水務署  
Water Supplies Department

**Approval of "MOEN" Thermostatic Mixer  
(General Acceptance No. C20220060)**

**Model:** 58332XXX  
(Where "XXX" denote the code of finishes)

**58332XXX**

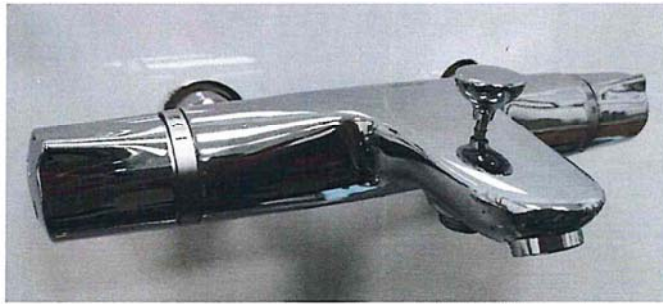
"The cold water supply to the fitting shall be drawn from the same source that supplies the hot water apparatus so as to provide a balanced pressure and to obviate the risk of scalding in the event of a restriction or failure in the water supply." AND

"The shower head or handspray should not be placed in submerged conditions and should be securely fixed to the original position after use."

A condition of this acceptance is that the fitting to be installed shall be replicas of the sample as certified by the testing agent mentioned above and without modifications. This acceptance may be withdrawn at any time if the standard of the fitting installed fails to meet that of the approved sample or if the fitting is found to be unsuitable for use in fresh water plumbing systems.

This acceptance is only applicable to the main body of the fitting, unless otherwise specified.
